Vermont Agency of Transportation
RECEIVED
CK'D BY TYLin/KMH OK'D BY KMH
July 7, 2017
RESUBMIT Yes Rejected
By Kristin M. Higgins DATE 07/11/2016

T.Y. LIN INTERNATIONAL
THE STAMPED DOCUMENTS ARE HEREBY:
APPROVED
APPROVED AS NOTED
REVISE AND RESUBMIT
SEE TRANSMITTAL FOR ADDITIONAL INFORMATION AS APPLICABLE
THIS REVIEW IS FOR GENERAL CONFORMANCE WITH DESIGN CONCEPT ONLY. ANY DEVIATION FROM THE PLANS OR SPECIFICATIONS NOT CLEARLY NOTED BY THE CONTRACTOR HAS NOT BEEN REVIEWED. REVIEW BY THE ENGINEER SHALL NOT RELIEVE THE CONTRACTOR OF THE CONTRACTUAL RESPONSIBILITY FOR ANY ERRORS OR DEVIATION FROM THE CONTRACT REQUIREMENTS.
JOHN OLIND REVIEWER July 11, 2016 DATE

VT 100 Road Culvert
Duxbury, Vermont
Culvert Layout - Plan and Elevation

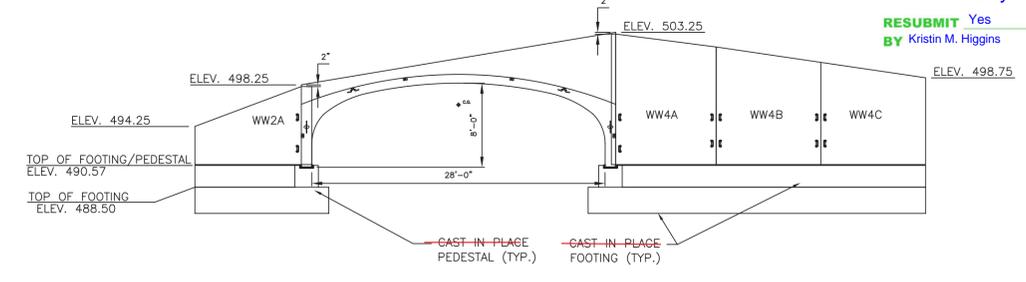
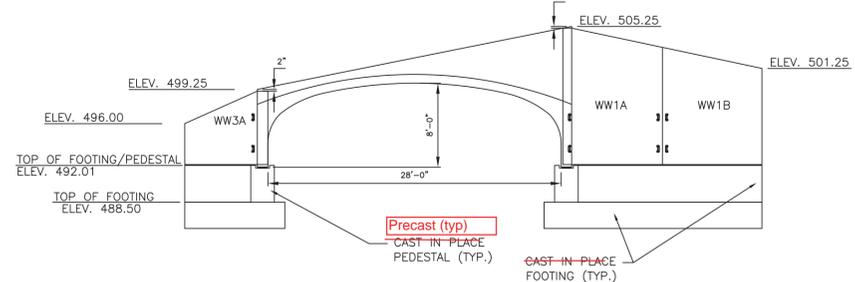
Confirm joint detail - this geometry is not defined nor shown on remaining arch fabrication sheets

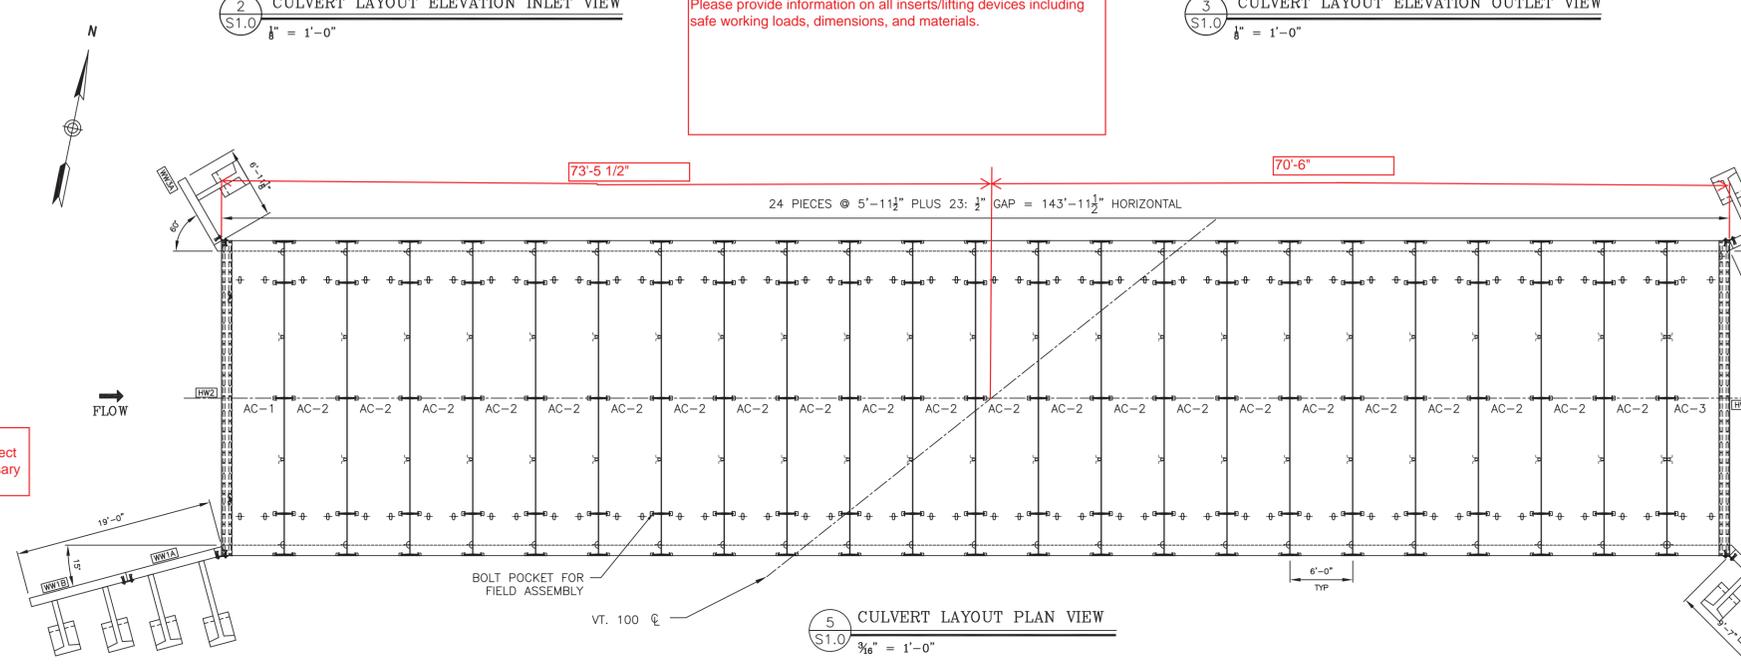
provide details/requirements (grout, shim)

6 WW4A ELEVATION
S6.0 1/2" = 1'-0"

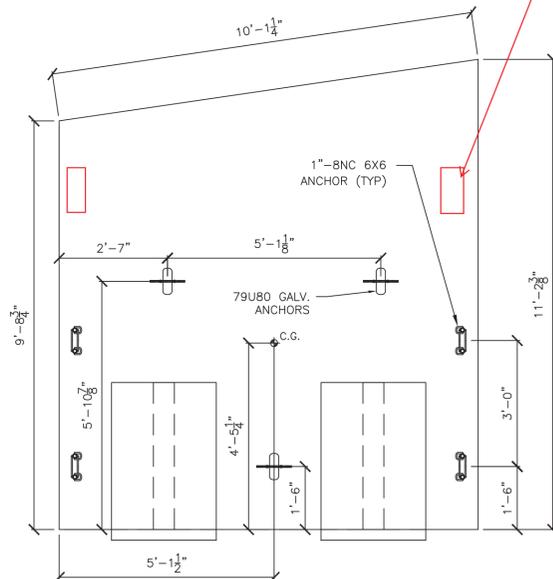
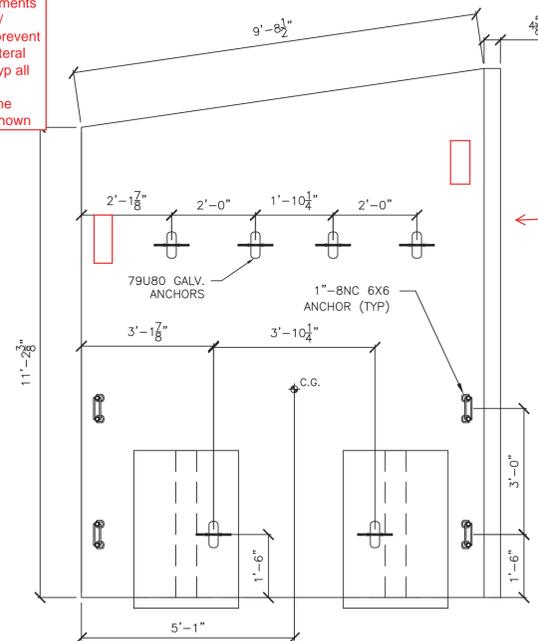
Provide additional anchor(s) between wingwall segments and wingwall/headwall to prevent differential lateral movement (typ all wings) or redistribute the connection shown

3 WINGWALL BRACKET DETAIL
S5.0 1" = 1'-0"

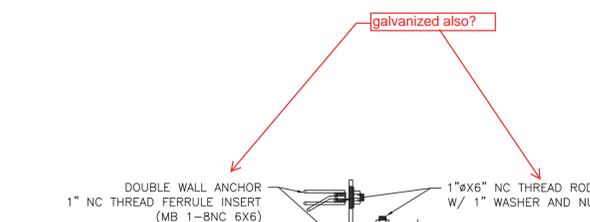
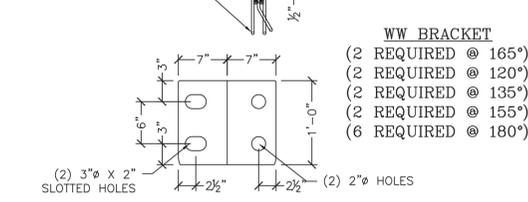
wall height?

galvanized also?

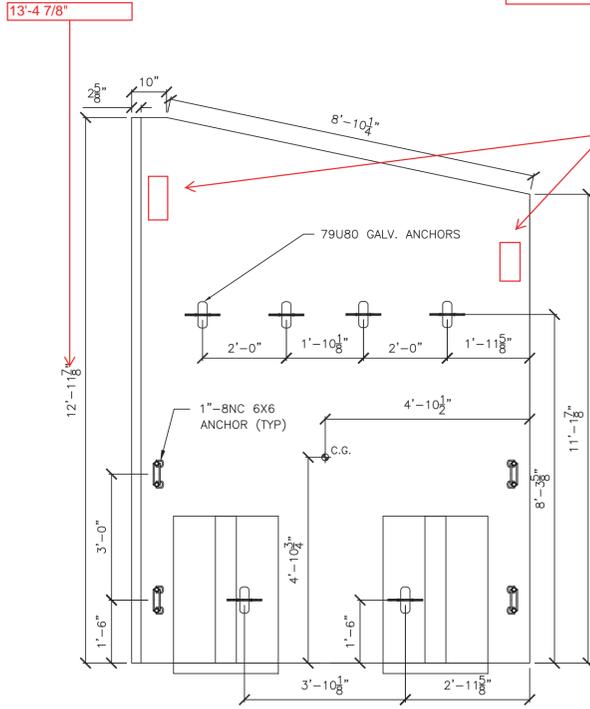
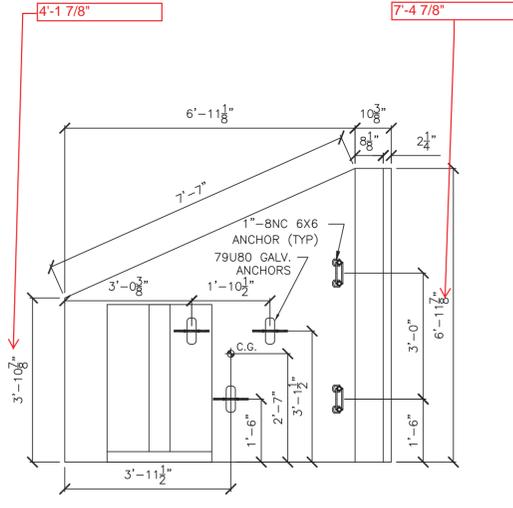
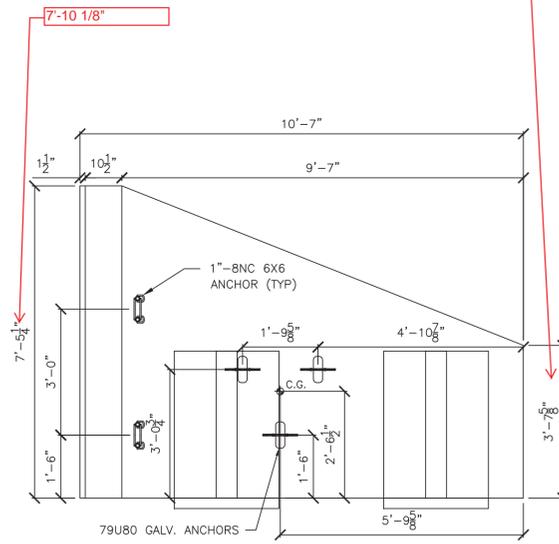
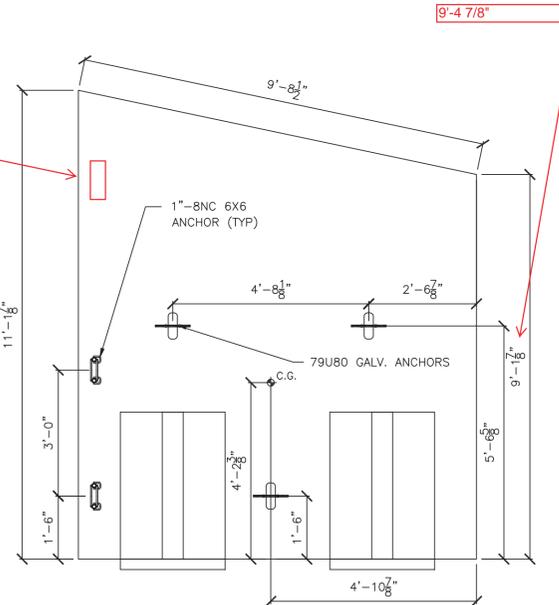
Wingwall 1 pieces appear to be drawn/detailed as if they will be placed where wingwall 3 should be.

Wingwall 3 appears to be drawn/detailed as if it will be placed where wingwall 1 should be.

Provide additional anchor(s) between wingwall segments and wingwall/headwall to prevent differential lateral movement (typ all wings)

3
S4.0
INLET HEAD WALL ELEVATION VIEW (HW2)
1/2" = 1'-0"

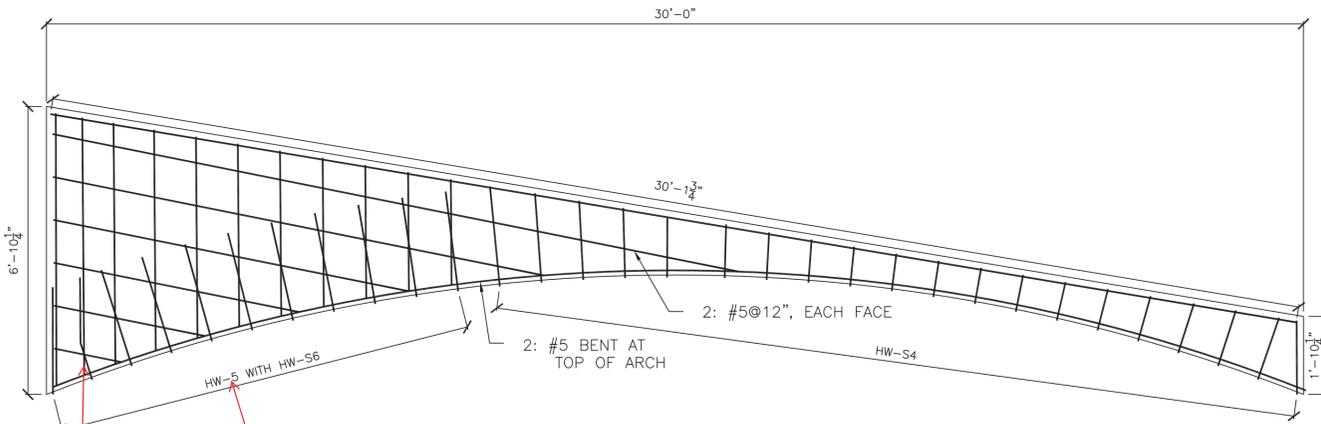
these bars are bent. dimensions of bend?

2 AC-2 PLAN VIEW
S3.0 3/8" = 1'-0"

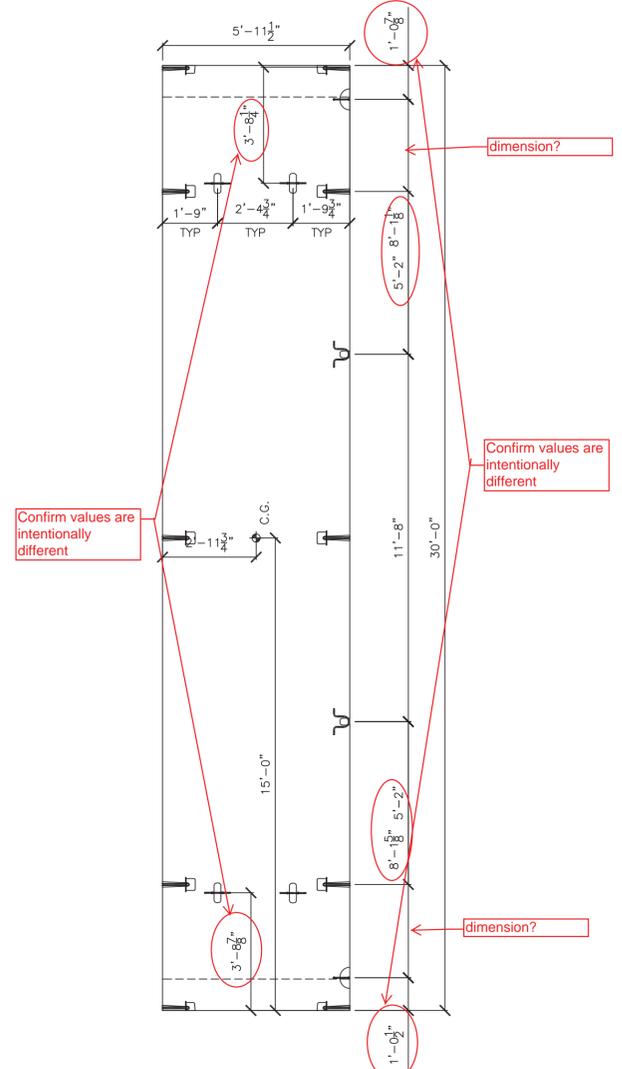
how far from the edge to start placing these? 2"?

Confirm values are intentionally different

3 AC-3 PLAN VIEW
S3.0 3/8" = 1'-0"

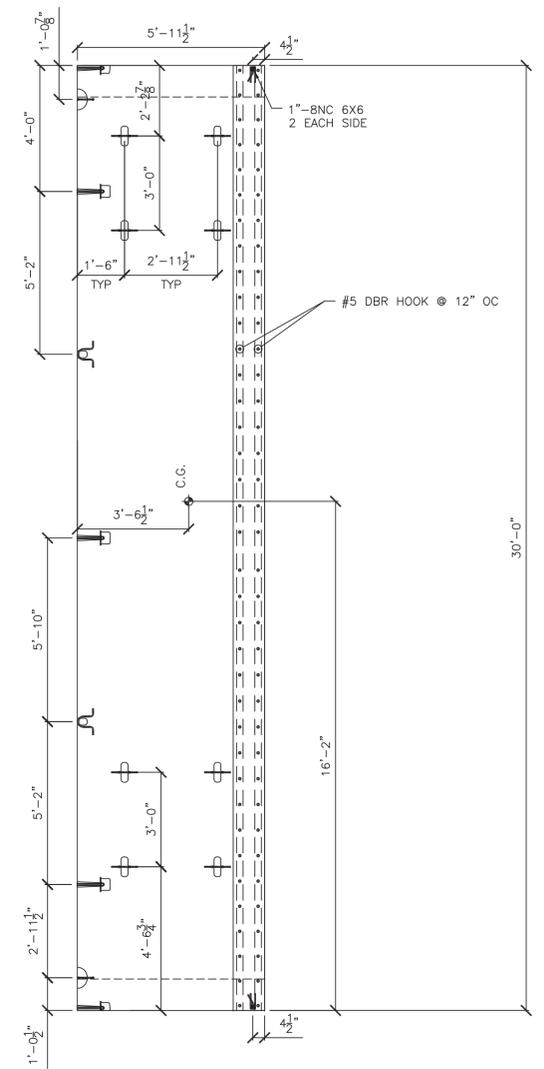
Confirm values are intentionally different

4 AC-1 ELEVATION VIEW
S3.0

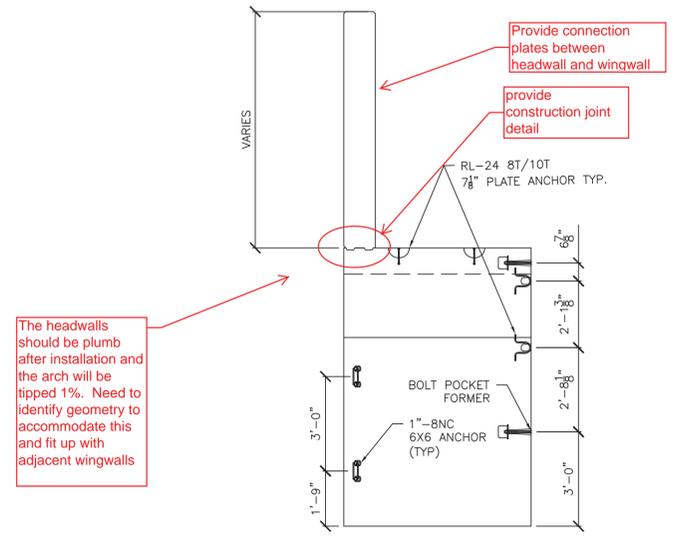
dimension?

The headwalls should be plumb after installation and the arch will be tipped 1%. Need to identify geometry to accommodate this and fit up with adjacent wingwalls

5 AC-2 ELEVATION VIEW
S3.0 3/8" = 1'-0"

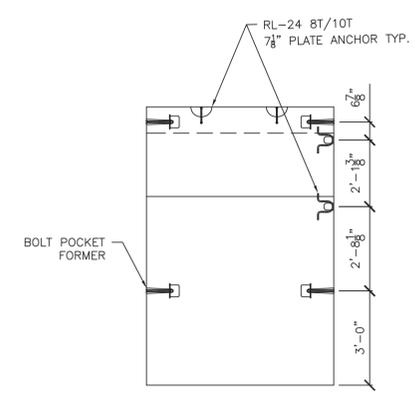
Provide connection plates between headwall and wingwall
provide construction joint detail

6 AC-3 ELEVATION VIEW
S3.0 3/8" = 1'-0"

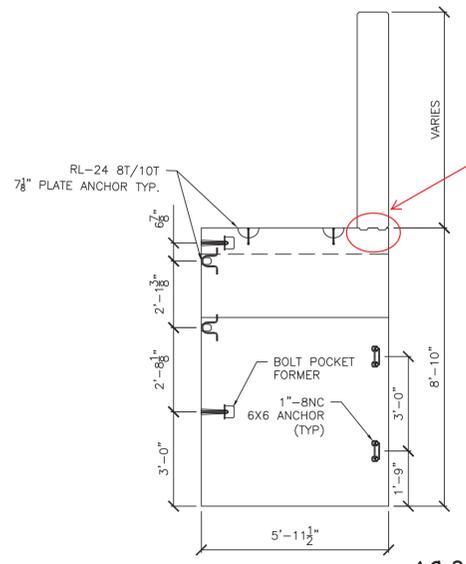
detail of key way dimensions?

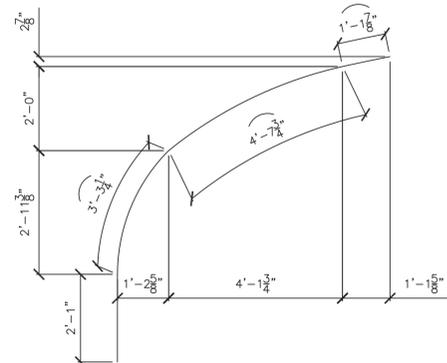
Bar Radius? (Typ for all bars this sheet)

dimension of these? Need 3 extra complete sets for testing. We would like at a very minimum of 7" of straight bar below the "bell" portion of the dowel bar insert. If there is not enough then they will have to order 3 without the 90° bend
